DOCUMENTATION OF COMMENTS EXTERNAL INDEPENDENT REVIEW PANEL AND RESOLUTION OF THESE ISSUES BY CORPS IN DECEMBER 2002 FINAL COMPREHENSIVE ECONOMIC REANALYSIS REPORT

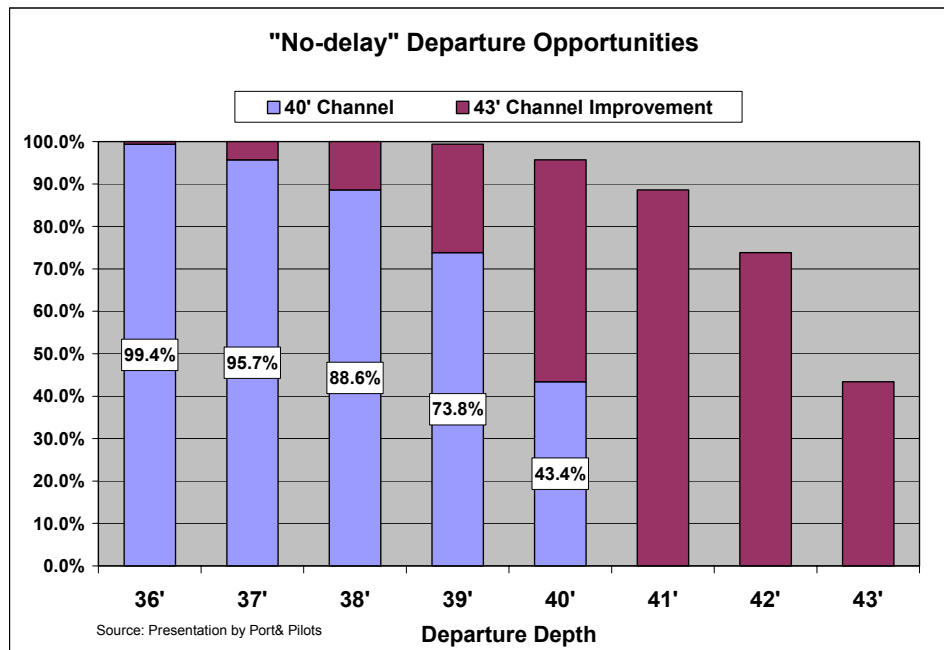
- Tides in the Delaware River reportedly favor arriving vessels headed upstream. A brief analysis of readily available information suggests that much of the time the channel would be deep enough to permit transit with 41 feet of arrival draft and 3 feet below the keel (44 feet total).

- Steaming time between Savannah and Philadelphia is roughly 30 hours (677 nautical miles at 23 knots, according to the Container Model). Unless the vessel departs Savannah between 7 AM and 11 AM, it cannot both arrive and depart during the day shift. More than likely, either the departure from Savannah or the arrival at Philadelphia will be on another shift, creating slack in the schedule that could accommodate occasional inbound delays waiting for the Delaware River tide.

The final version of the report will contain an analysis of forecasted departure drafts from Savannah (arrival drafts at Philadelphia) that will indicate the estimated year in which without-project channel depths at the Delaware River constrain arrival drafts for the planned eastbound P&O/Columbus Line VSA service from Australia/New Zealand.
